URBAN DESIGN COMMISSION APPLICATION

Title: CAPITAL VIEW APARTMENTS

CAPITOL VIEW AT OAK PARK

Letter of Intent

SHEET NAME
**OVERALL SECOND FLOOR
PLAN**

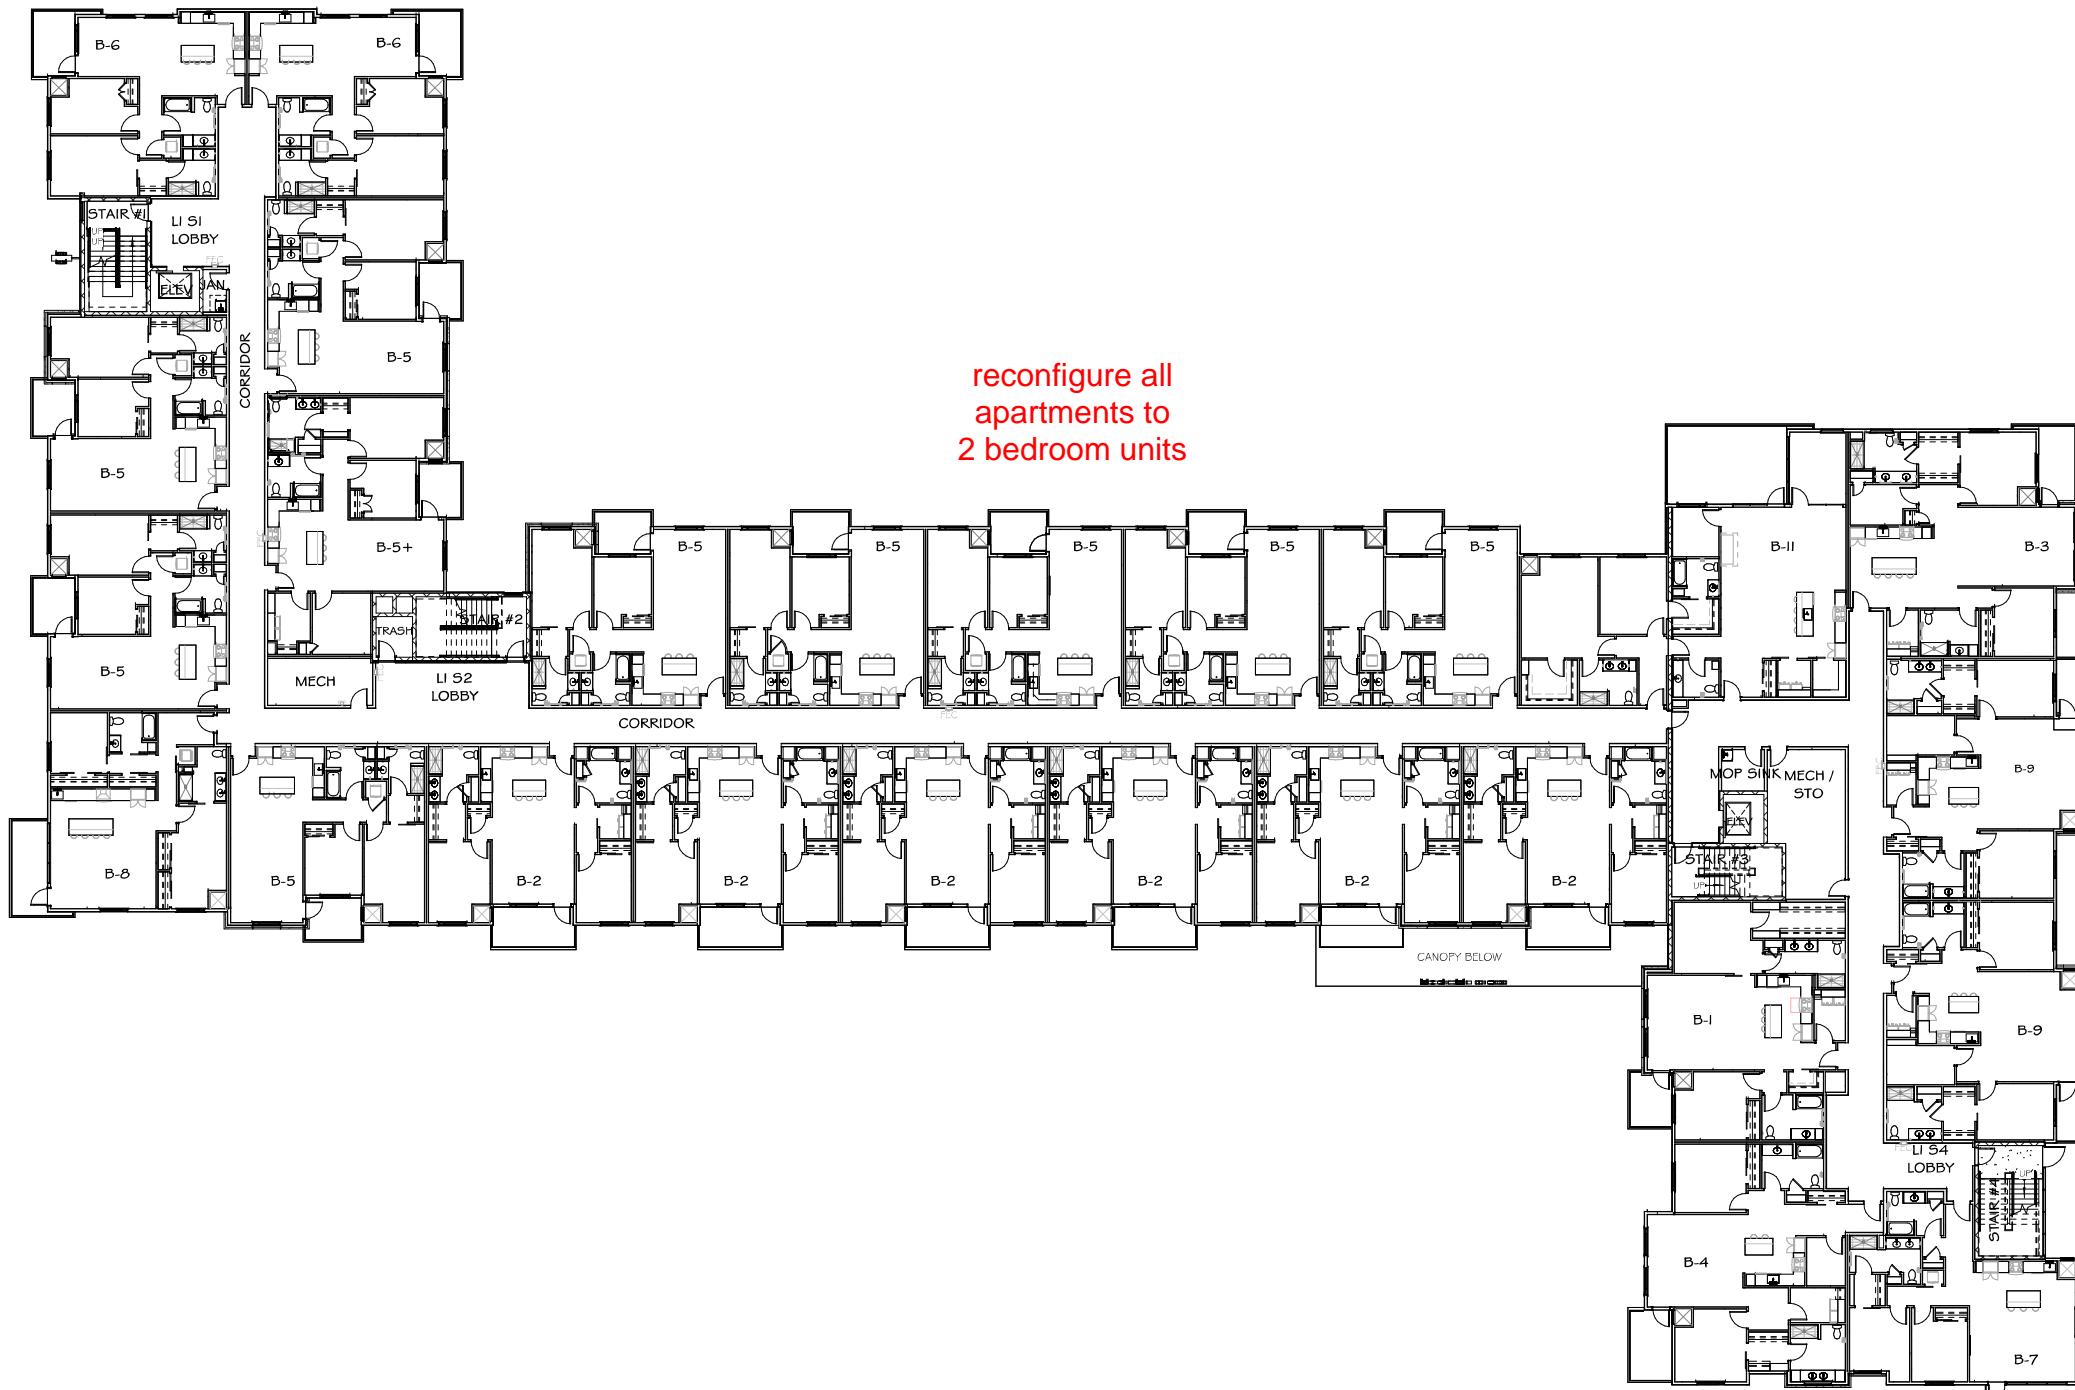
— Add units to second floor

— Add units to second floor

reconfigure all
apartments to
2 bedroom units
